CFC Percy St. Auburn

13 Percy Street, Auburn, NSW 2144

S4.55 - AMENDMENT LIST

ISSUE FOR S4.55

Drawing Title:
Mezz 2/L1 Floor Plan

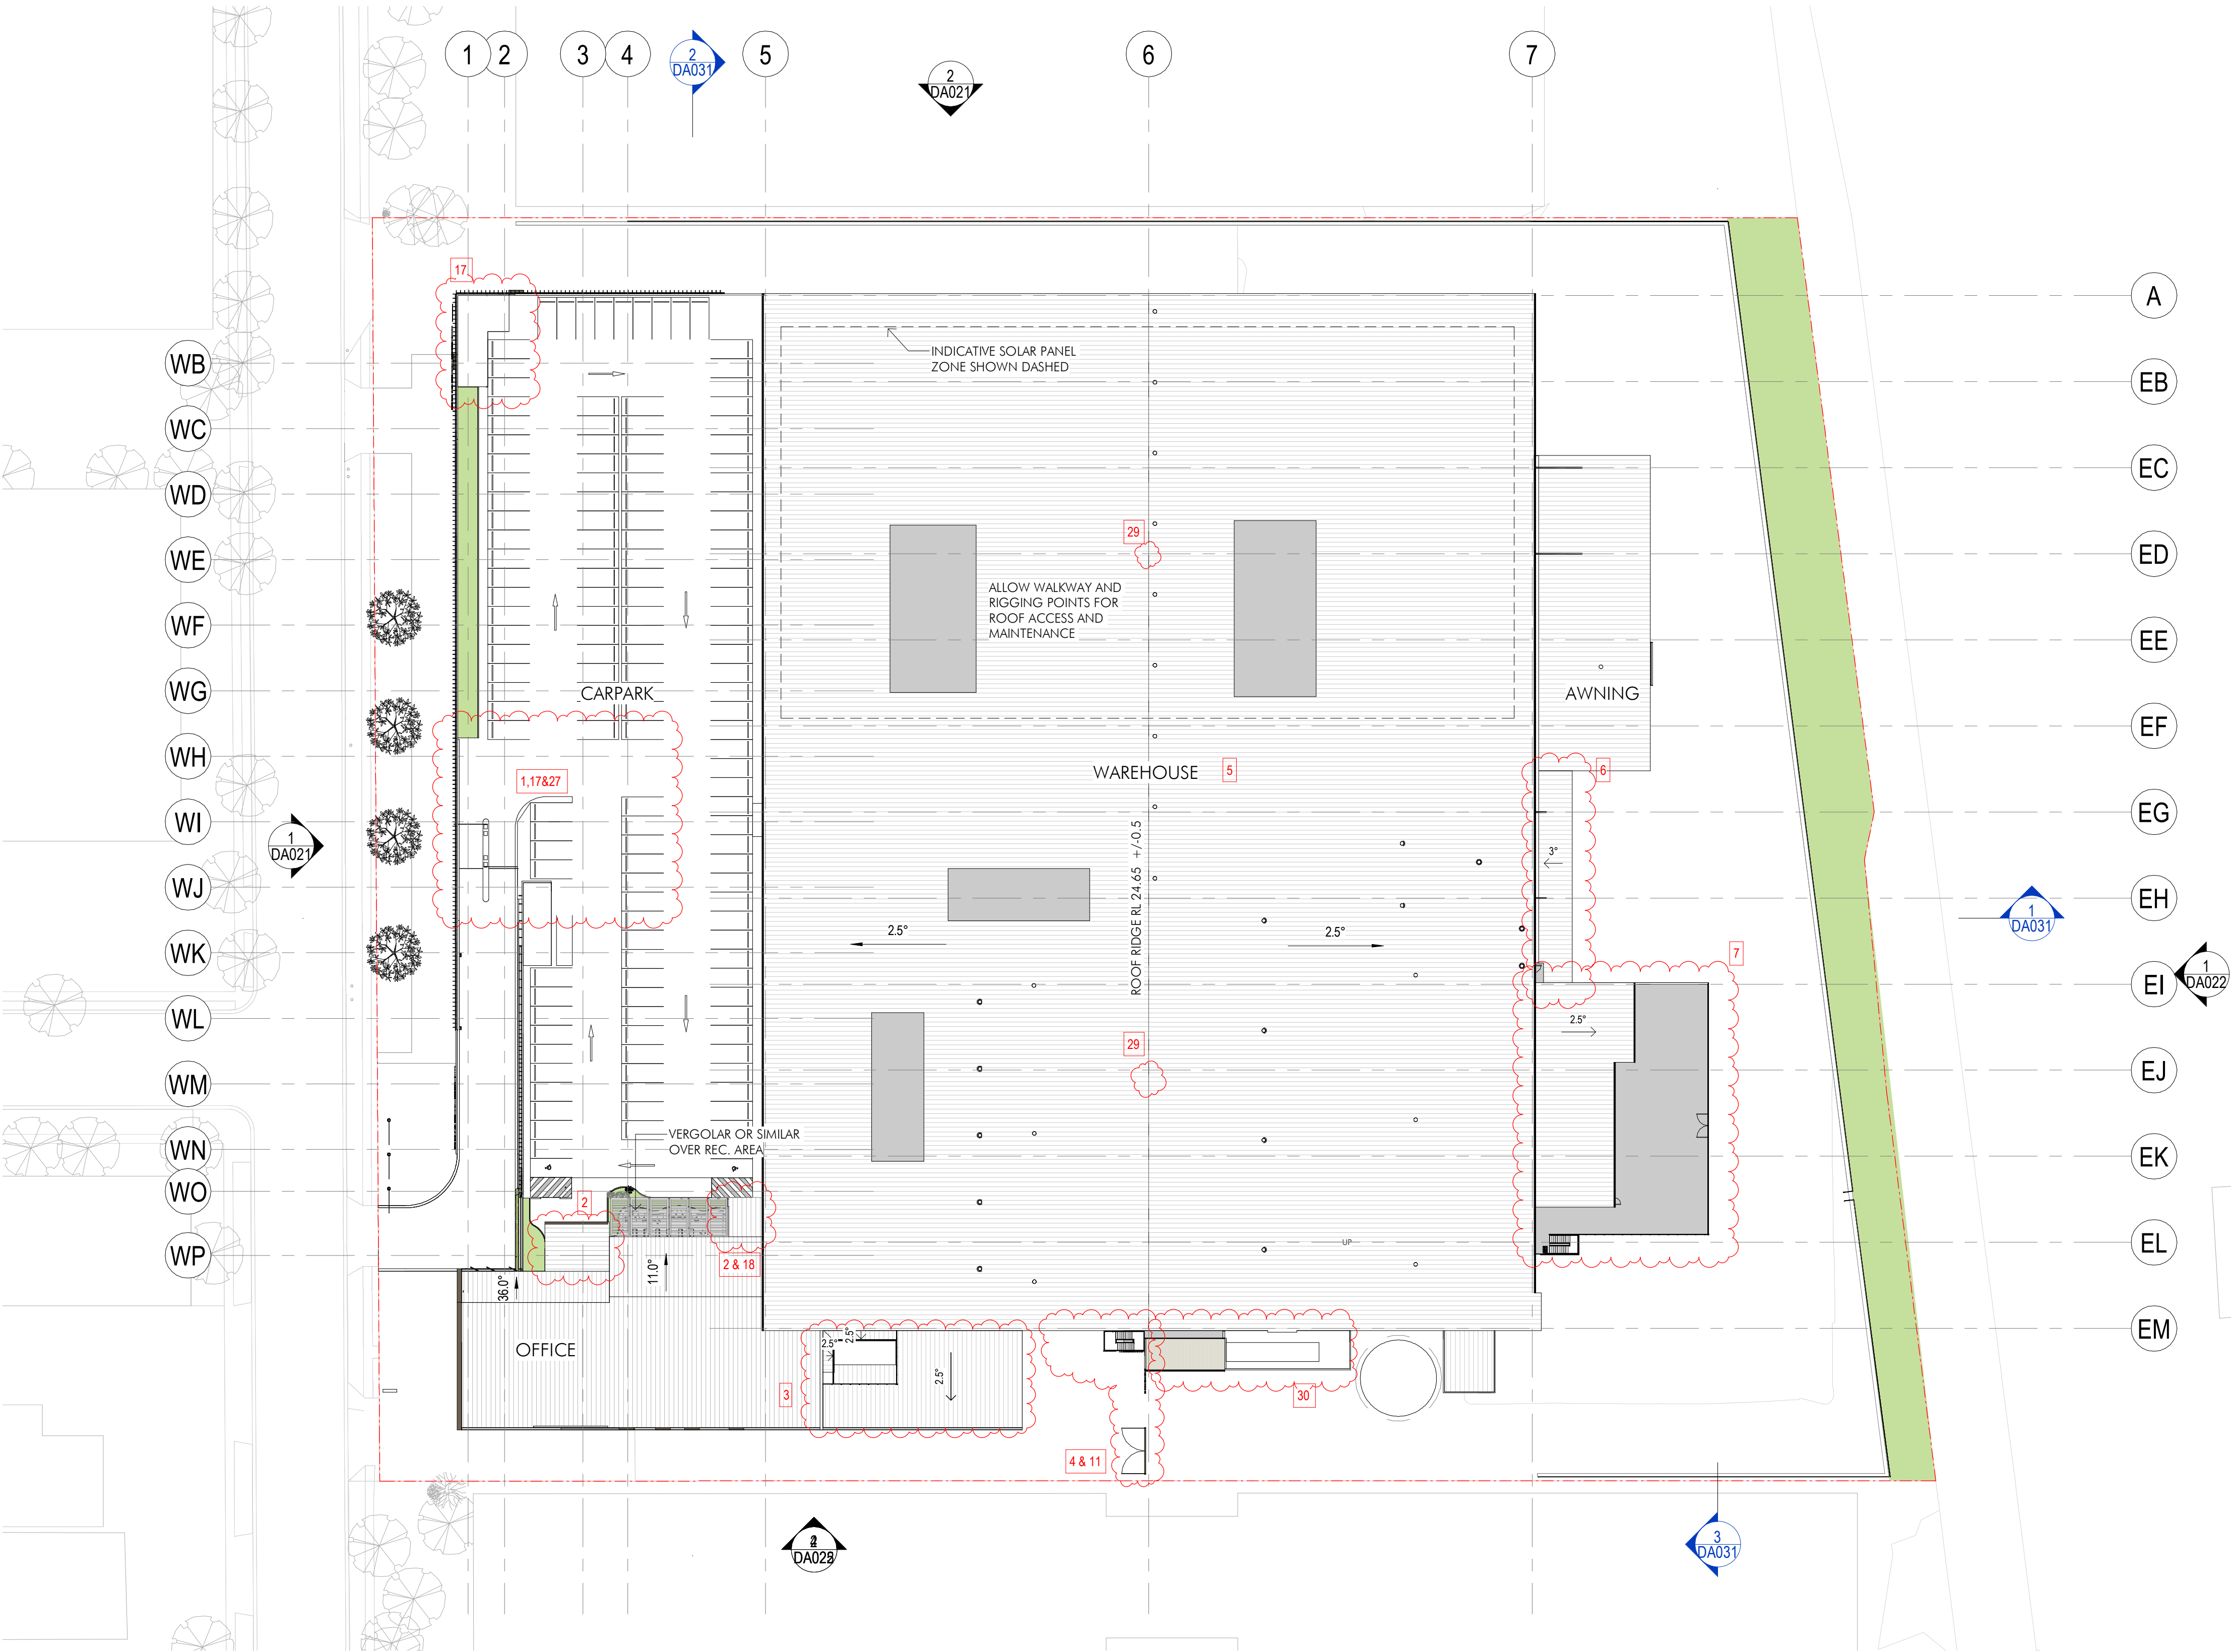
- Carpark layout change due to additional mech.plant rooms & boomgate
- Extension of roof over L1 office entry
- Added external egress stair, awning over DTB bays and plant deck

- Added external egress stair to access mezz. floors and roof
- Added mech. exhaust & plant on roof & removed translucent roof sheets
- Inbound dock awning is reduced

- Added mech & refrigeration plant rooms on rear elevated plant deck, and associated egress stair
- Added removal of existing concrete channel in demolition

- Additional DTB store and DTB bays, including changed configuration of DTB bays
- Office internal layout amended
- Added landscape area, aluminium screen & gates

- Southern plant area layout changed as following
 - Solar and switch room layout reconfigured
 - Sub & HVC updated
 - Permanent generator reduced to single large gen. Portable gen is added

- Diesel tank is added for backup generators
 - Armco is added around sub & sprinkler plant area
 - One (1) van parking relocated
- Precast wall is erected higher to support the rear elevated plant deck

- Maintenance and wash bays are added
- Added an external stair to inbound dock area
- Security gates added
- Boom gates added
- Minor enlarged L1 office lobby & additional stair next to rec area

- NOT USED
- Mech. Louvre added
- Heavy duty guardrail added to suspended slab edges
- Replaced transparent wall sheeting to Longline metal cladding
- Pickup graphic extended

- CFC sheeting is removed from Office ground elevation
- NOT USED
- Outbound Loading dock size & Van parking size increased (TBC)
- Two mechanical plant rooms on carpark level added

- Added 3 flag poles
- Added 2 lightning poles
- Added generator on slab above switch and solar rooms
- Sign 03 & Sign 04 amended
- Two (2) signs (Sign 06 & Sign 07) added

- South-east stair relocated

Drawing Title
Roof Plan

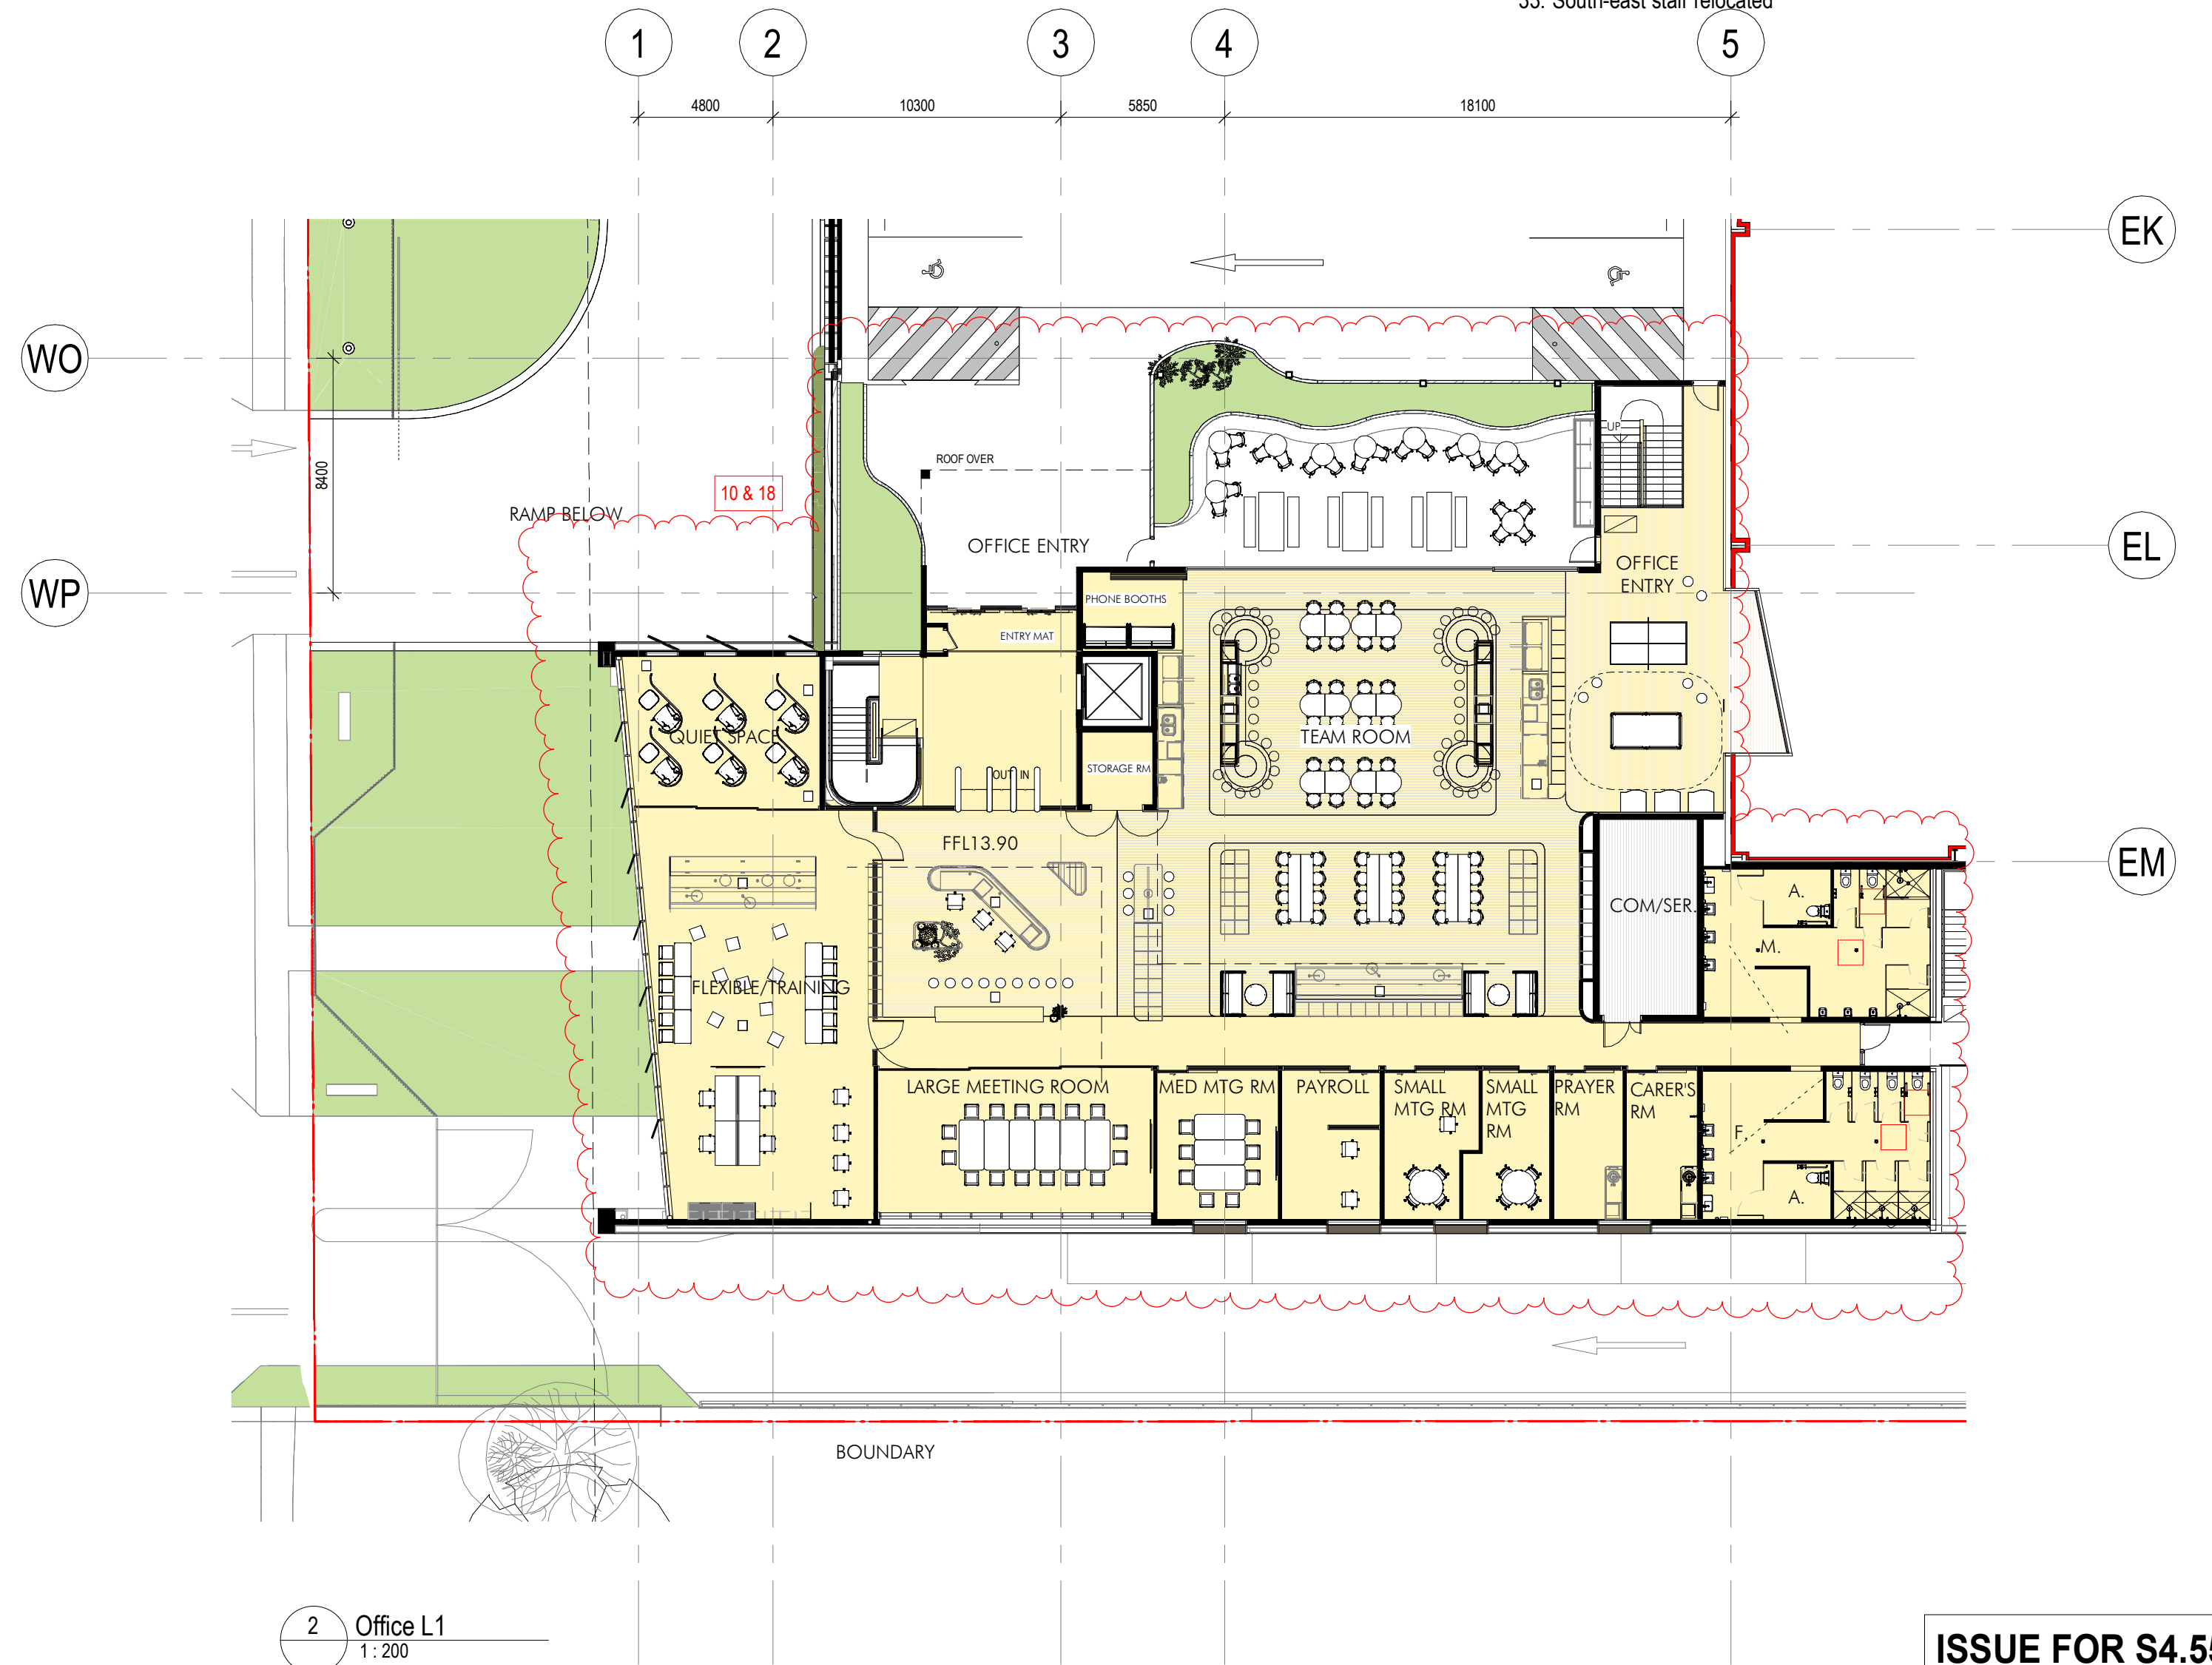
1. Carpark layout change due to additional mech.plant rooms & boomgate
2. Extension of roof over L1 office entry
3. Added external egress stair, awning over DTB bays and plant deck

4. Added external egress stair to access mezz. floors and roof
5. Added mech. exhaust & plant on roof & removed translucent roof sheets
6. Inbound dock awning is reduced

7. Added mech & refrigeration plant rooms on rear elevated plant deck, and associated egress stair
8. Added removal of existing concrete channel in demolition

9. Additional DTB store and DTB bays, including changed configuration of DTB bays
10. Office internal layout amended
11. Added landscape area, aluminium screen & gates

12. Southern plant area layout changed as following
 - Sub and switch room layout reconfigured
 - Sub & HVC updated
 - Permanent generator reduced to single large gen. Portable gen is added

- Diesel tank is added for backup generators
 - Armco is added around sub & sprinkler plant area
 - One (1) van parking relocated
13. Precast wall is erected higher to support the rear elevated plant deck

14. Maintenance and wash bays are added
15. Added an external stair to inbound dock area
16. Security gates added
17. Boom gates added
18. Minor enlarged L1 office lobby & additional stair next to rec area

19. NOT USED
20. Mech. Louvre added
21. Heavy duty guardrail added to suspended slab edges
22. Replaced transparent wall sheeting to Longline metal cladding

23. Pickup graphic extended
24. CFC sheeting is removed from Office ground elevation
25. NOT USED
26. Outbound Loading dock size & Van parking size increased (TBC)

27. Two mechanical plant rooms on carpark level added
28. Added 3 flag poles
29. Added 2 lightning poles
30. Added generator on slab above switch and solar rooms

31. Sign 03 & Sign 04 amended
32. Two (2) signs (Sign 06 & Sign 07) added
33. South-east stair relocated

Drawing Title: Elevations - Sheet 1			
Author: ES	Checker:	Sheet Size: A1	Scale: 1:300
Drawing Number: 11250_DA021			Issue: J

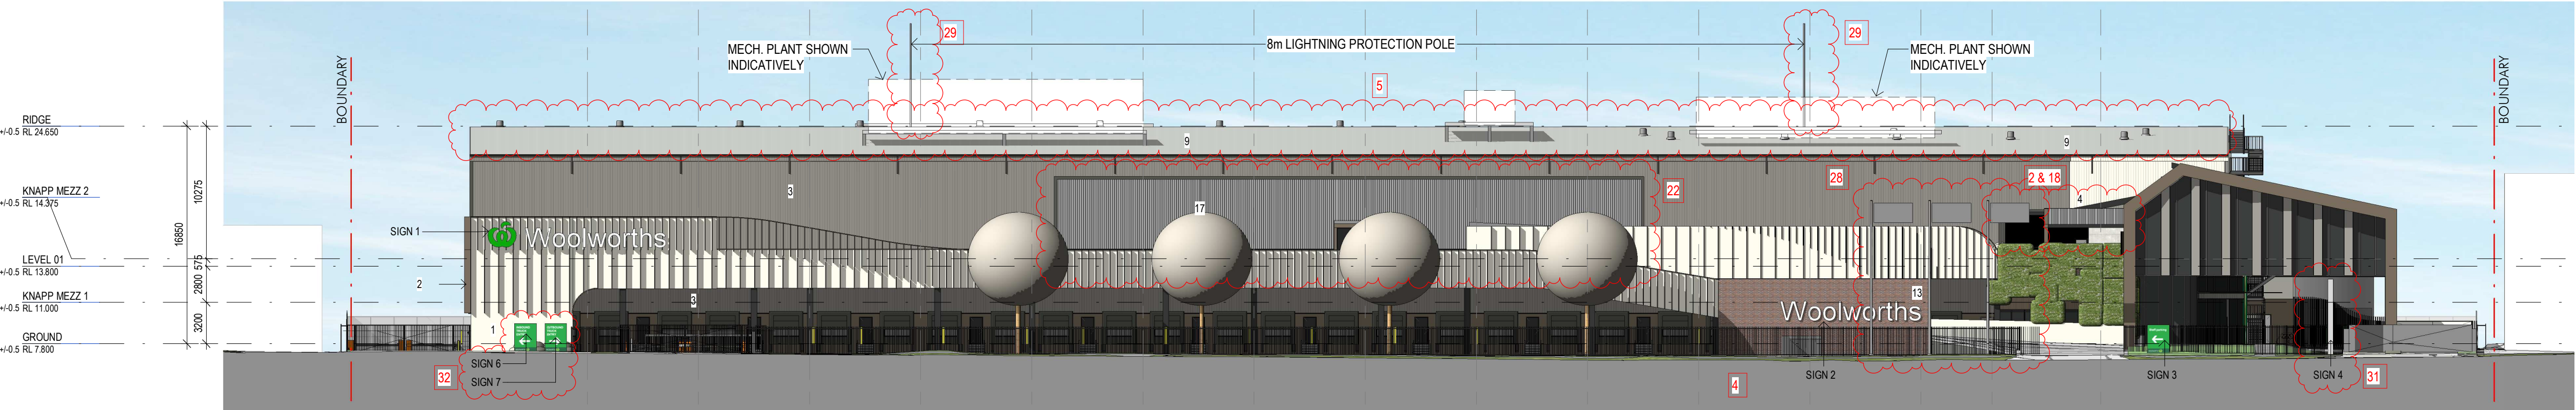
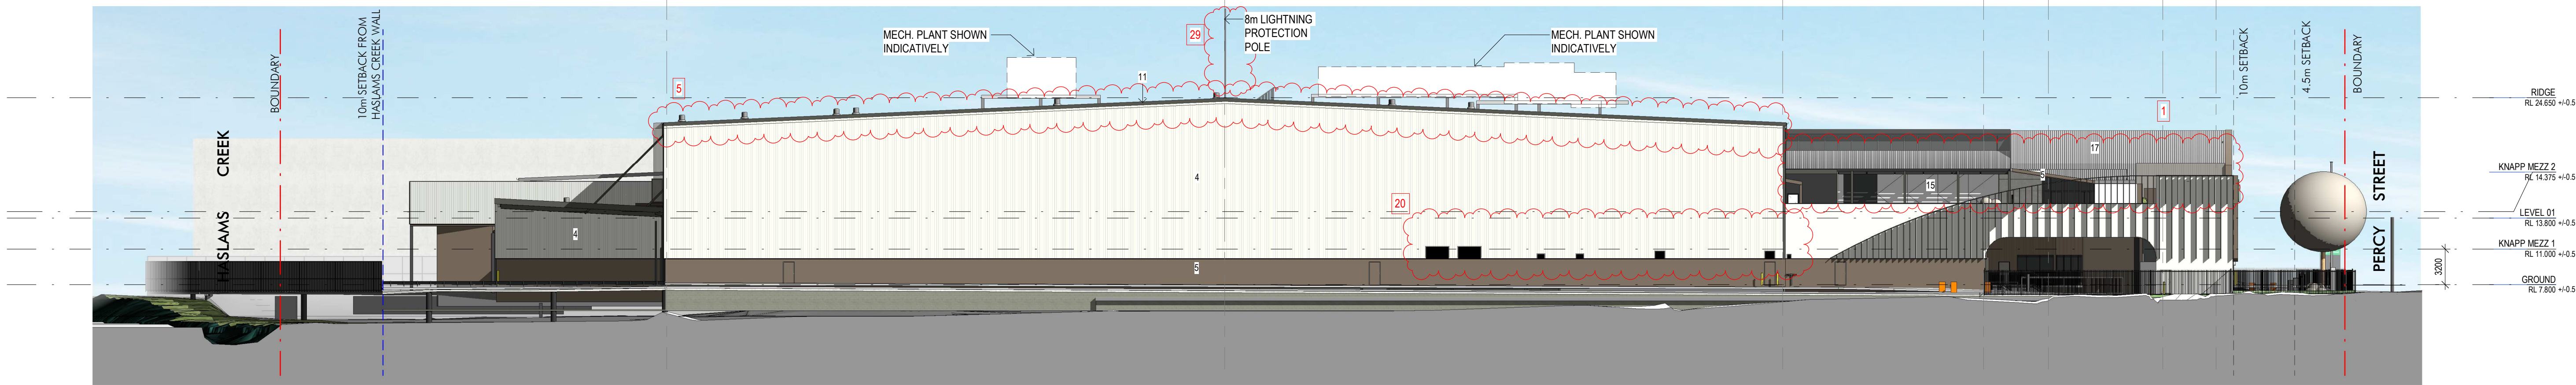
- Carpark layout change due to additional mech.plant rooms & boomgate
- Extension of roof over L1 office entry
- Added external egress stair, awning over DTB bays and plant deck

- Added external egress stair to access mezz. floors and roof
- Added mech. exhaust & plant on roof & removed translucent roof sheets
- Inbound dock awning is reduced

- Added mech & refrigeration plant rooms on rear elevated plant deck, and associated egress stair
- Added removal of existing concrete channel in demolition

- Additional DTB store and DTB bays, including changed configuration of DTB bays
- Office internal layout amended
- Added landscape area, aluminium screen & gates

- Southern plant area layout changed as following
 - Solar and switch room layout reconfigured
 - Sub & HVC updated
 - Permanent generator reduced to single large gen. Portable gen is added

- Diesel tank is added for backup generators
 - Armco is added around sub & sprinkler plant area
 - One (1) van parking relocated
- Precast wall is erected higher to support the rear elevated plant deck

- Maintenance and wash bays are added
- Added an external stair to inbound dock area
- Security gates added
- Boom gates added
- Minor enlarged L1 office lobby & additional stair next to rec area

- NOT USED
- Mech. Louvre added
- Heavy duty guardrail added to suspended slab edges
- Replaced transparent wall sheeting to Longline metal cladding
- Pickup graphic extended

- CFC sheeting is removed from Office ground elevation
- NOT USED
- Outbound Loading dock size & Van parking size increased (TBC)
- Two mechanical plant rooms on carpark level added

- Added 3 flag poles
- Added 2 lightning poles
- Added generator on slab above switch and solar rooms
- Sign 03 & Sign 04 amended
- Two (2) signs (Sign 06 & Sign 07) added

- South-east stair relocated
